BEACON PLANNING BOARD
Via Video-Conference
BEACON, NEW YORK 12508
Phone (845) 838-5002 Fax (845) 838-5026

Beacon Views - Conklin Street

Continue public hearing for SEQRA environmental review on applications for Subdivision and Site Plan Approval, "Beacon Views Townhouses" 40 units, Conklin Street, submitted by Beacon Views, LLC

RE: Beacon Views Site Plan and Conservation Subdivision
Conklin Street
Beacon, New York
Tax Parcel ID: 6055-03-331123

PROJECT NUMBER: 19131.100 PROJECT MANAGER: J.J.C. DRAWING NO.: SHEET: 3
 DATE: 8-27-19 DRAWN BY: J.F.R. SCALE: AS SHOWN CHECKED BY: A.D.T.

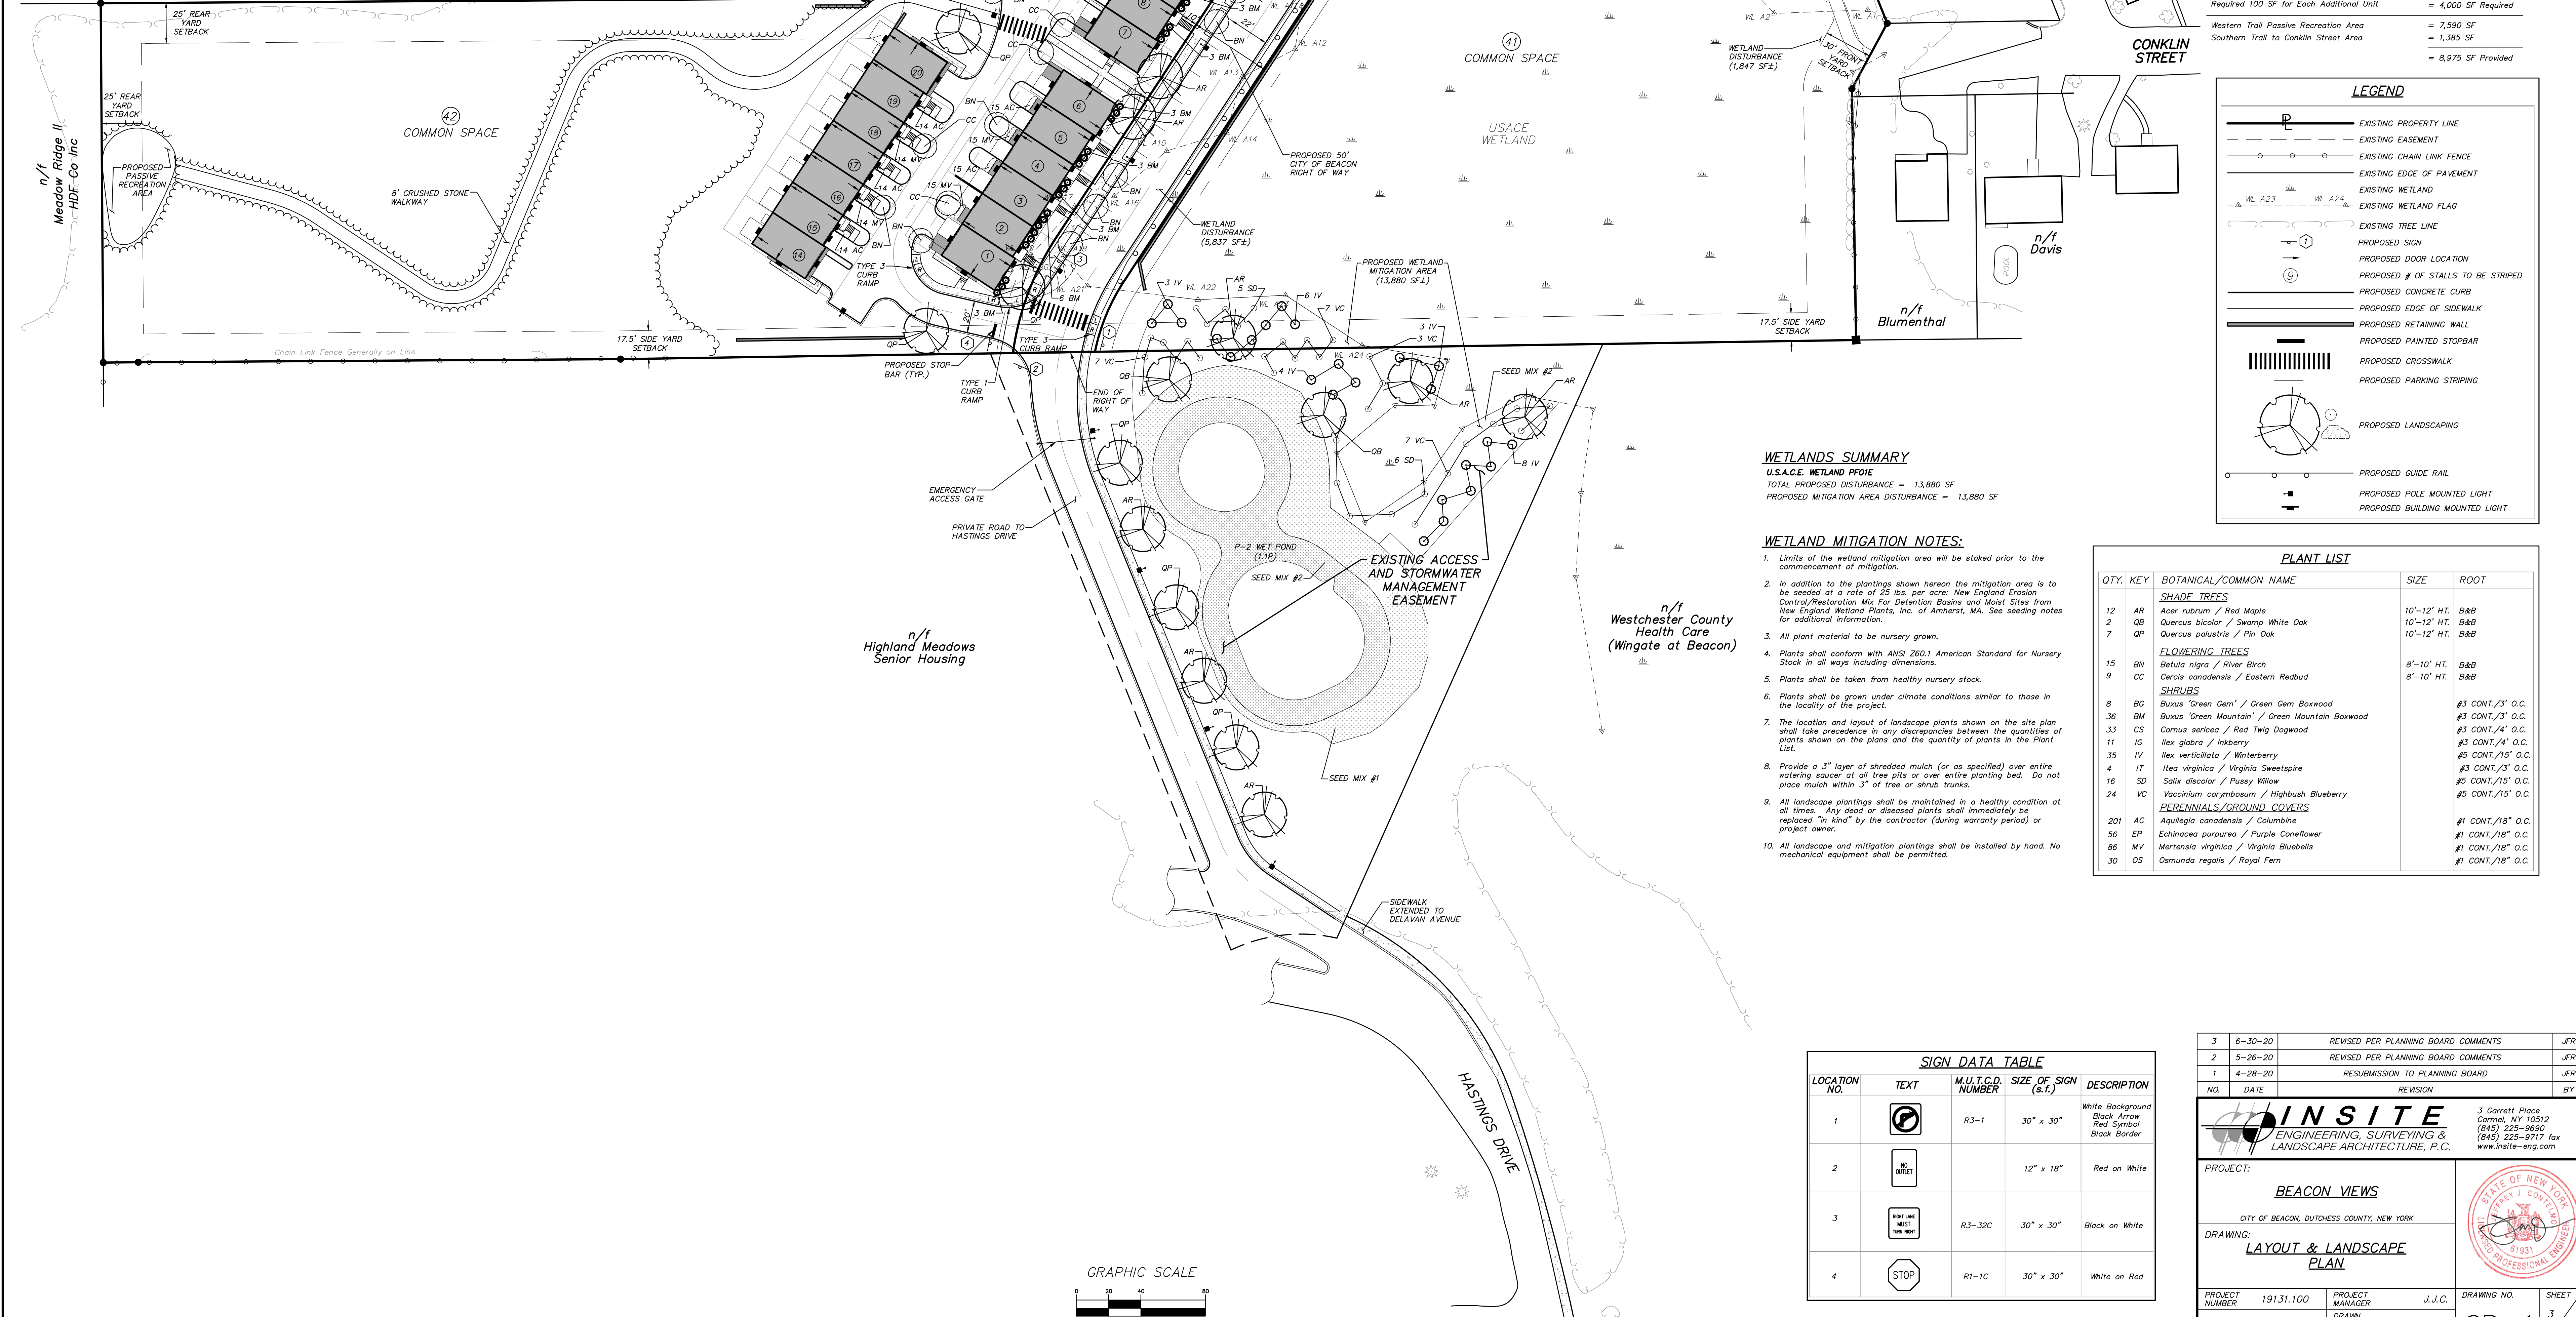
3. For the Sheet SP-1 Layout and Landscape Plan, the previous April 28, 2020 version had what appeared to be paths through the central landscaped island, which are now missing. Can this green area be designed to be more usable, with walkways, benches, and a few shade trees?

Layout & Landscape Plan (Sheet 3 of 16):

DRAWING NO. SHEET: **SP-2.1** 4/16

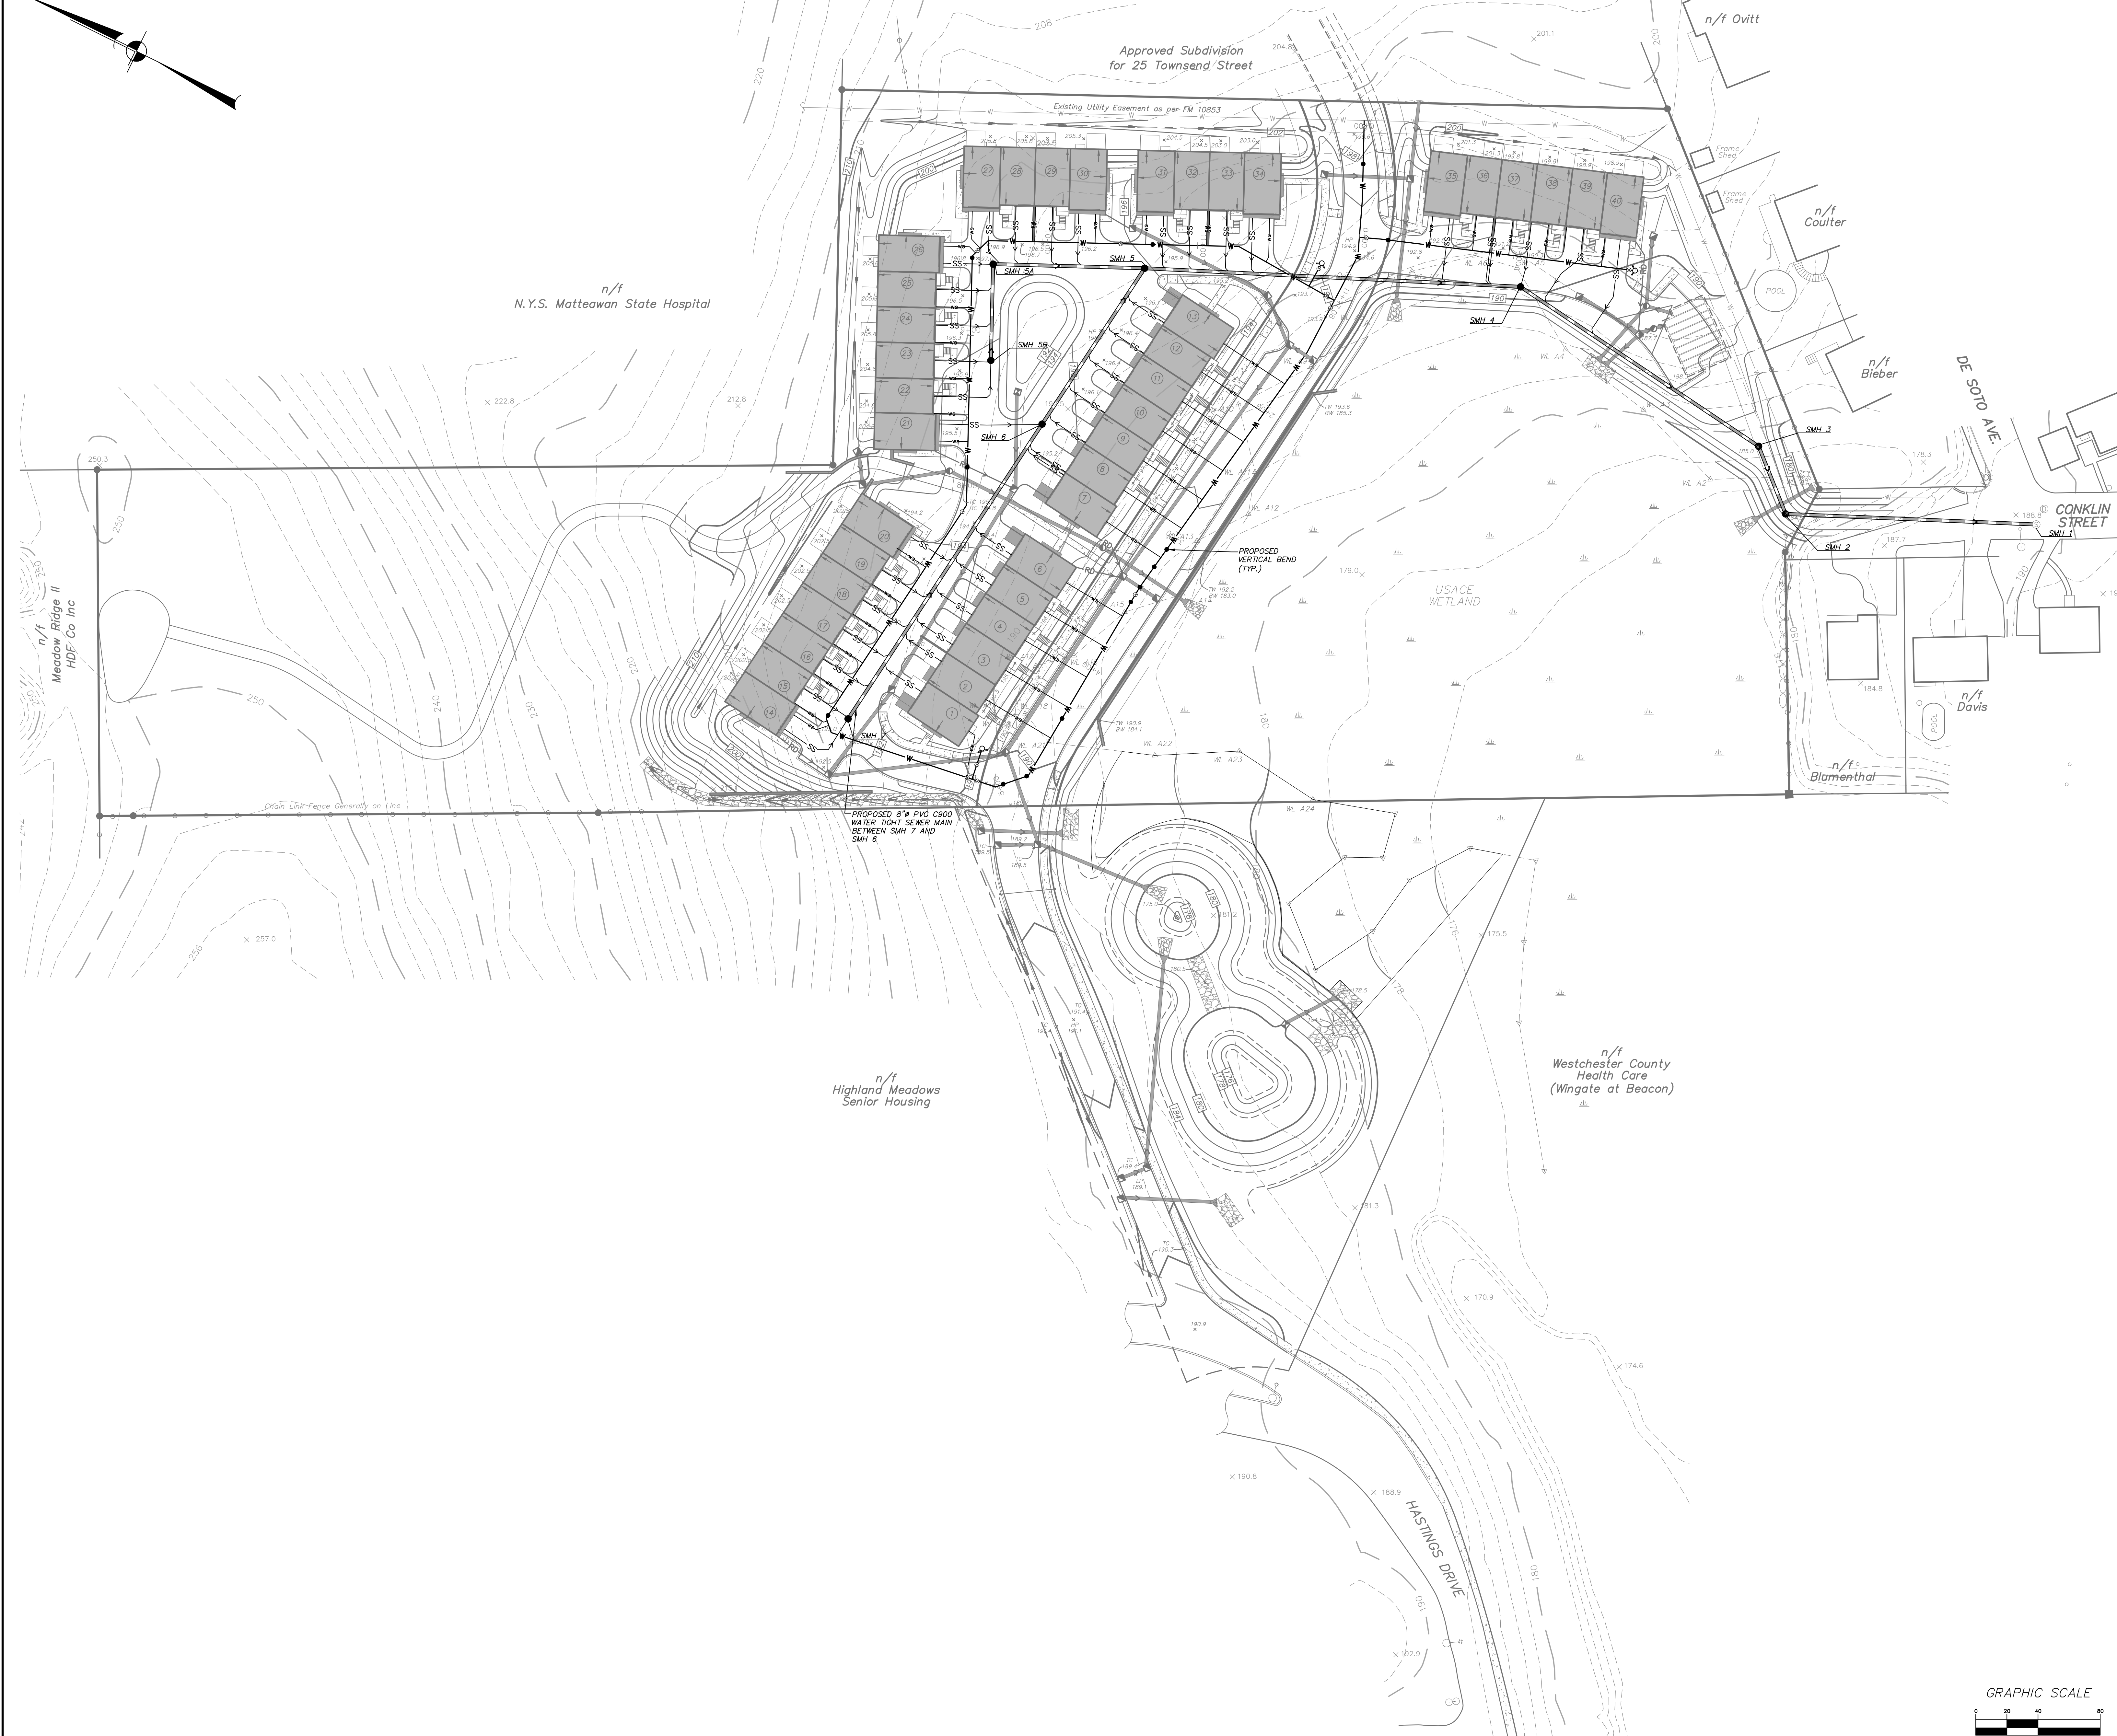
Grading & Drainage Plan (Sheet 4 of 16):

1. These comments are addressed above.
2. The retaining wall and drainage have been moved, so there is sufficient distance between the wall and drain line to accommodate the geogrid.
3. It is understood that the responsibility of the maintenance of the onsite stormwater management practices lies with the applicant.
4. The revised plans include a note granting the City the right to maintain the proposed city drainage from CB 3 to ES 1, if the applicant fails to fulfill their maintenance obligations.

PROJECT NUMBER: 19131.100 PROJECT MANAGER: J.J.C. DRAWING NO.: SP-2.2 SHEET: 5 OF 16

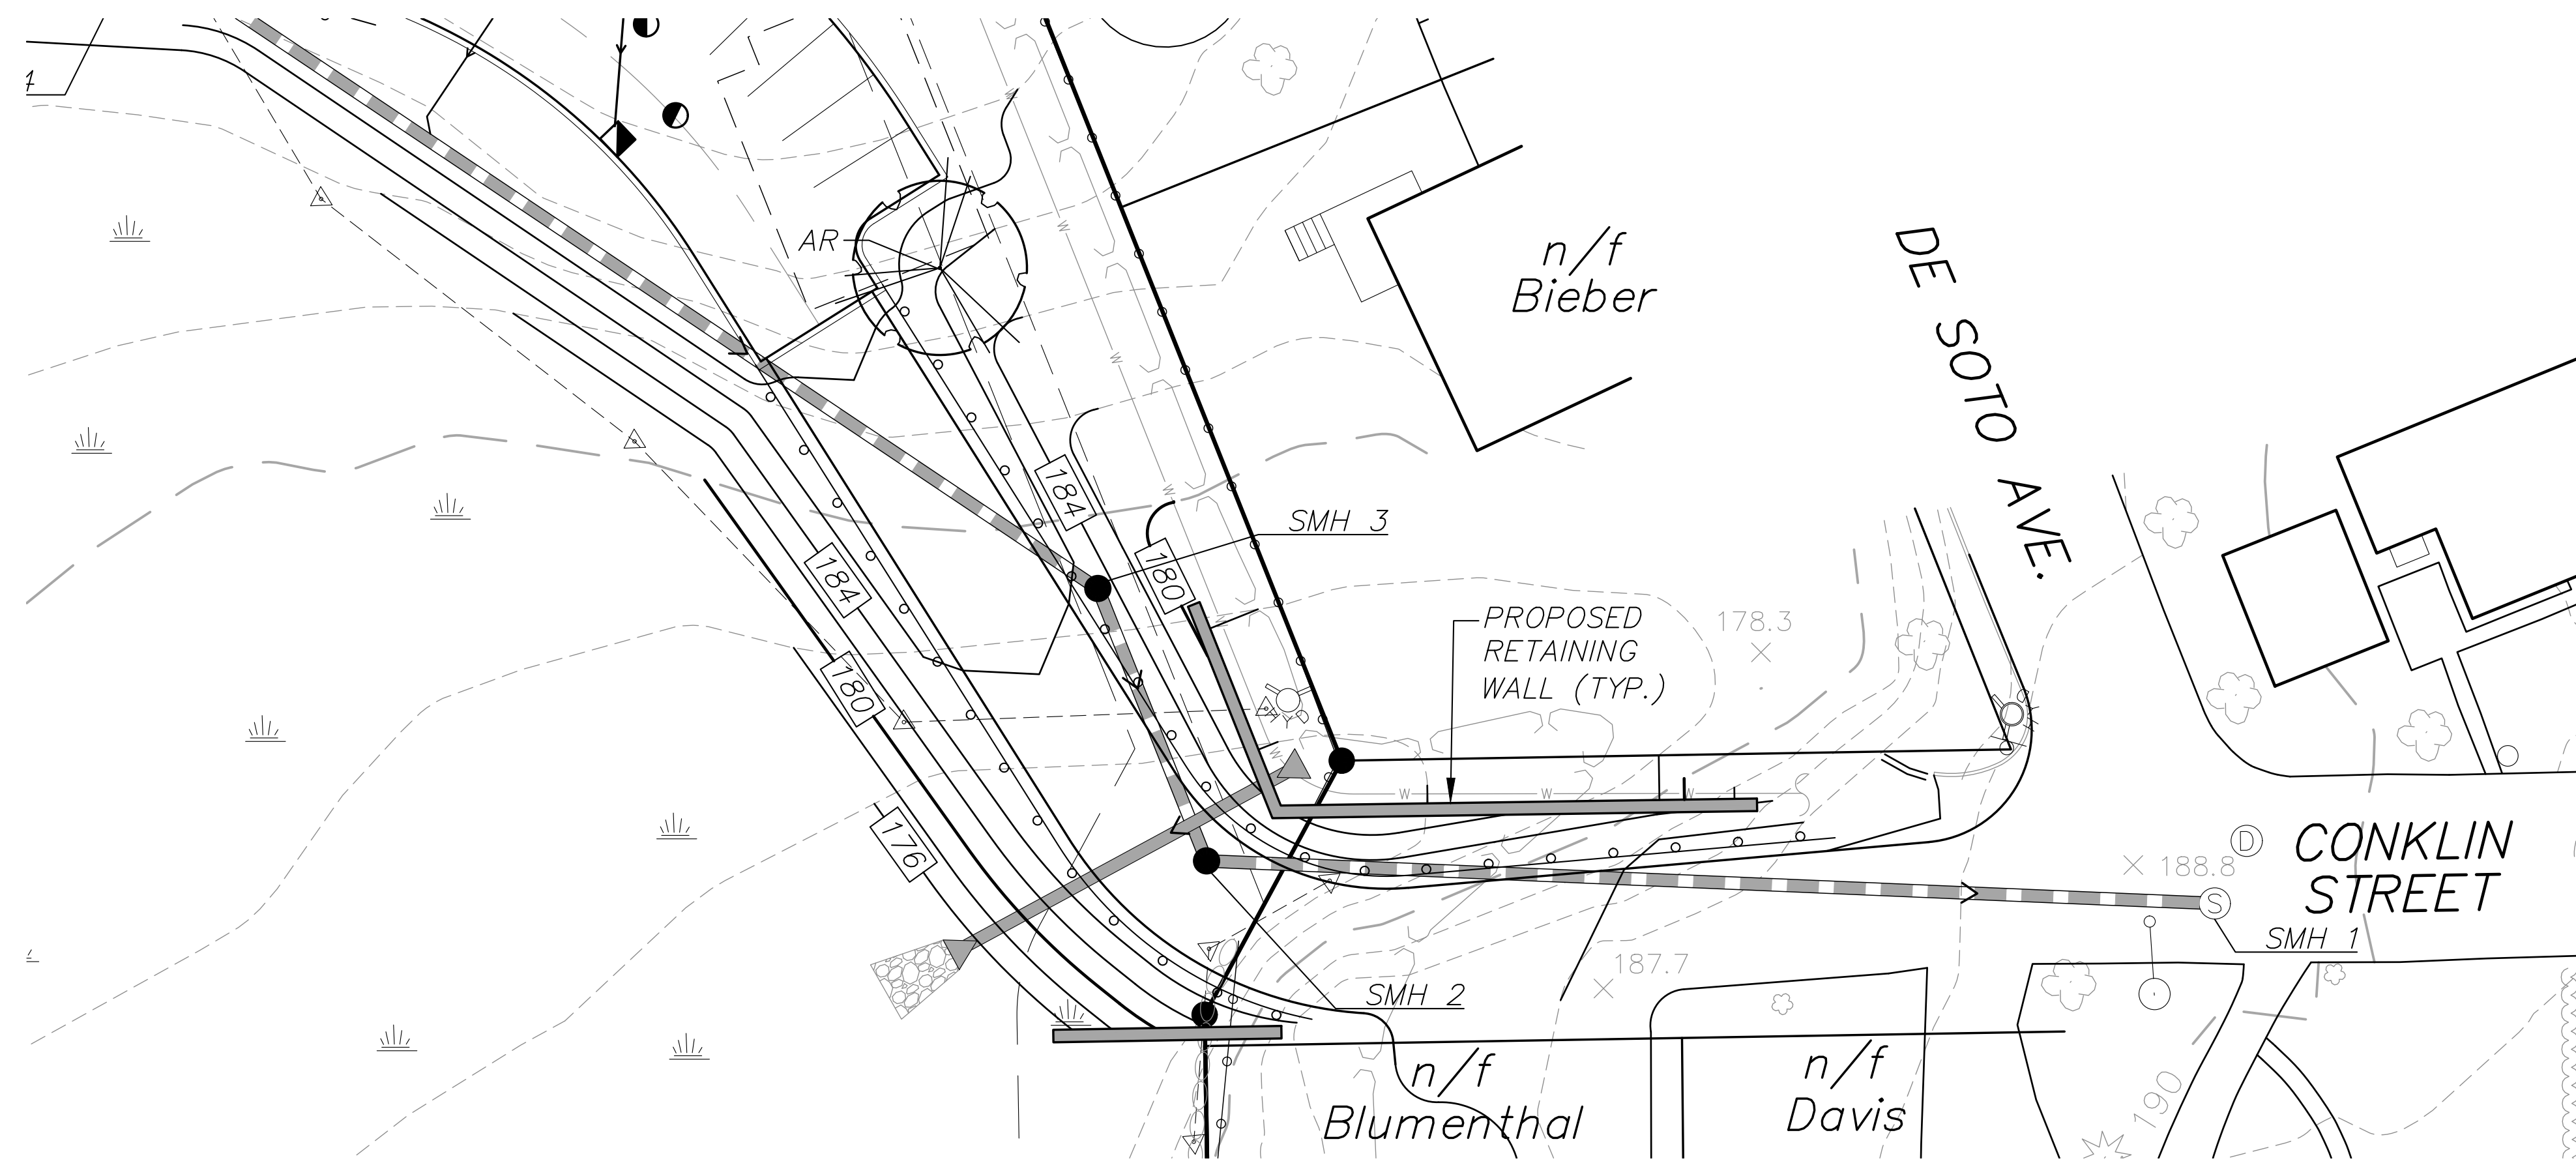
Utilities Plan (Sheet 5 of 16):

1. Notes have been added to sheets SP-2.1 & SP-2.2 addressing the stormwater, sewer and water utilities to be dedicated to the city.
2. The plans have been revised to show the proposed connection to the Town of Fishkill transmission line that traverses the property.

6. The proposed fire hydrant near unit #1 has been relocated as suggested.
7. Additional in line valves have been added to the proposed watermain loop for ease of potential future maintenance.

8. Additional valves have been added to either side of the hydrant tee near unit #1 to facilitate future testing and maintenance of the system.
9. Stationing of the proposed water main have been added to the plan for correlation with the profile sheets.
